LEE VISTA WAREHOUSES #3 MPL SOUTH ENDS OF TPC & TG LEE BLVDS.

Applicant's Request: Master Plan approval to construct up to three (3) spec warehouses totaling ±1,515,600 sq. ft., to be located on a 91.6-acre parcel in the Airport North neighborhood. The request includes a future land use change from Conservation to Metropolitan Activity Center and a re-

Staff Recommendation: Approval of the Master Plan, subject to conditions in this staff report.

SITE PLAN

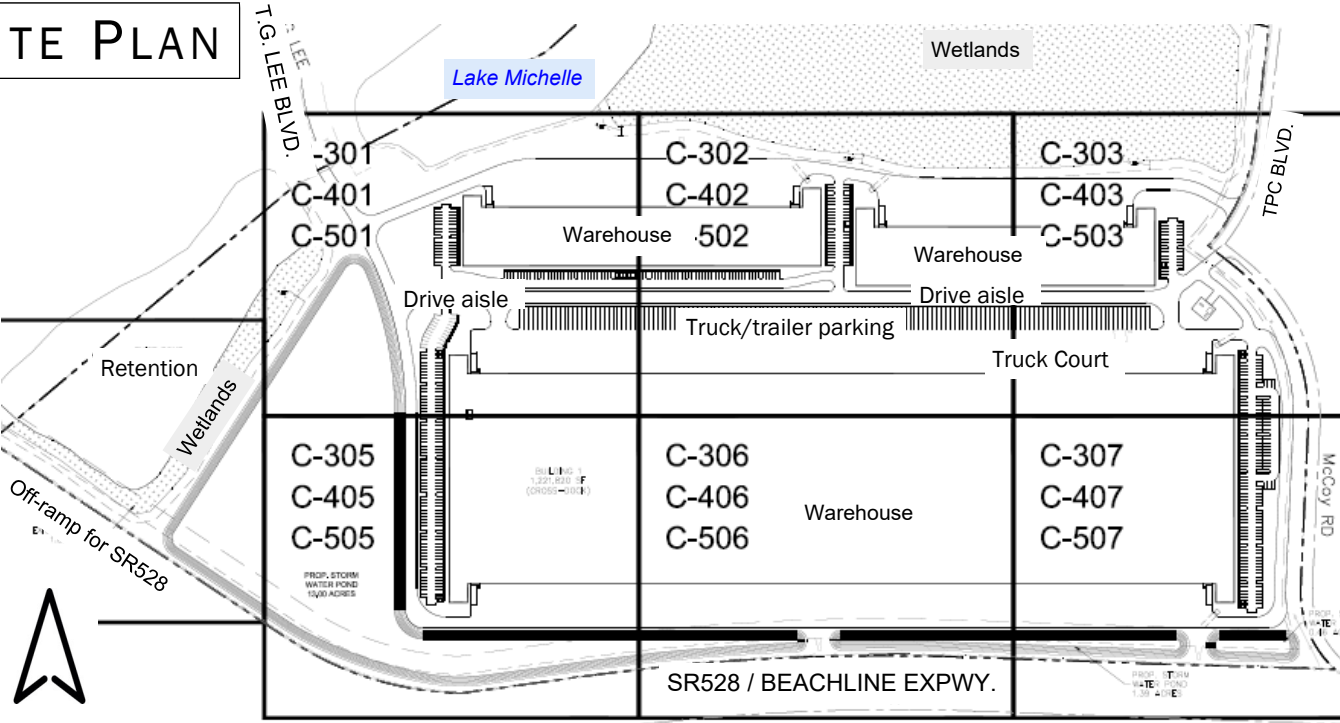
Dumpster areas appear to be only single enclosures. Plans must be provided for double enclosures for refuse containers. Per the City Code Chap. 28 mandatory recycling ordinance, all new commercial properties are required to have a double enclosure that accommodates both a garbage and recycling container. Further specifications can be found in City Code Chapters 28 and 58, as well as the Engineering Standards Manual on the last page of the "details" section.

1. This property (as depicted on the site plan in this report) is required to **plat** in accordance with LDC Section 65.401 prior to the issuance of building permits. A Hold Harmless agreement and deposit can be submitted at time of replat submittal to allow temporary satisfaction of the replat condition following TRC review of the plat application.

East & West ELEVATIONS (larger Warehouse) and Front ELEVATION (for smaller Warehouses), as viewed from east, west and central lane

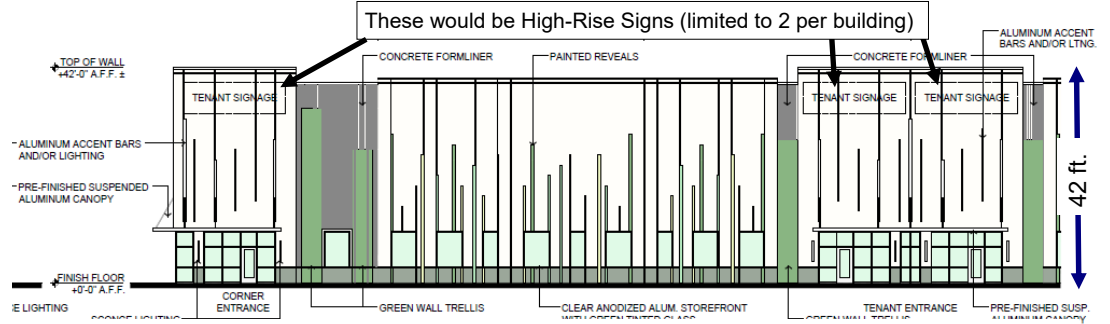
NO Truck Court ELEVATIONS PROVIDED

4. For industrial building facades, a base, middle, and top must be expressed, with materials, finishes, and details wrapped on all facade corners to a logical architectural end point.

5. Primary pedestrian entries must be clearly expressed and highlighted and recessed or framed by a sheltering element such as an awning, arcade, porch, portico, or canopy.

6. A minimum of 30% building transparency is required on all facades facing a public or private right-of-way or street. Warehouse buildings must contain window slats between 5 and 7-ft. from the finished floor on roll-up doors facing truck loading/unloading areas.

LANDSCAPE PLAN

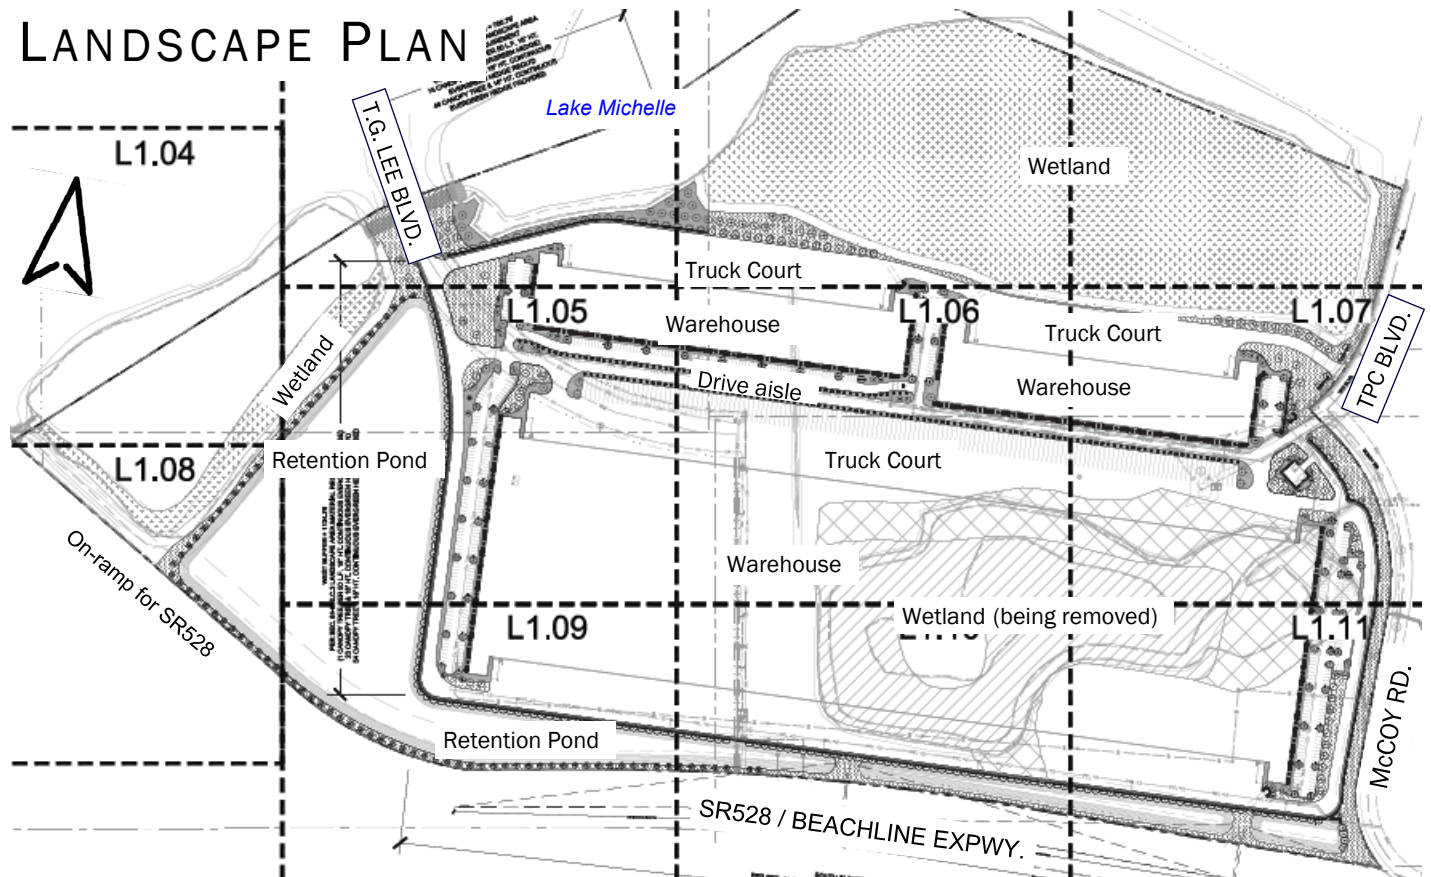
7. Street trees are required along the TG Lee Blvd extension into the property, TPC Blvd., and McCoy Rd. as well as any internal roadways. Said street trees must be canopy trees and planted per LDC Sec. 60.216. If an obstruction exists (i.e. powerlines), understory trees may be used in lieu of canopy trees.

8. All landscape plans must achieve the Minimum Required Landscape Score (MRLS) required for the proposed type and intensity of development. Meet City Code Chapters 60 and 61. A spreadsheet showing compliance with the MRLS must be included with the plans when submitted for permits. A digital spreadsheet form is available at <http://www.cityoforlando.net/city-planning/landscape-code/>.

9. All vehicular use areas must be sufficiently screened from any street. Such screening should utilize a combination of groundcovers, hedges, and understory trees. This screening is in addition to any canopy trees that are required around the perimeter of vehicular use areas and in any row-end/intermediate landscape islands.

10. All trees located around the parking lot perimeters and within all row-end and intermediate landscape islands must be canopy trees. Specific plantings must be provided at time of permitting. All parking lot landscaping must comply with LDC Sec. 61.312.

11. Loading docks must be adequately screened from public streets, especially as it concerns potential views from the Beachline Expressway.
12. A hedge is required around the perimeter of both the regular parking and the truck staging parking lots. The hedge must be a minimum 3-ft. tall at the time of planting and maintained at a minimum 4-ft. height.

13. Trees must also be planted around the perimeter of all truck staging parking lots and stormwater detention ponds at a minimum of 50 ft. on center. Required trees must be canopy trees, must have a minimum caliper of 2 in., and a minimum overall height of 12 ft.
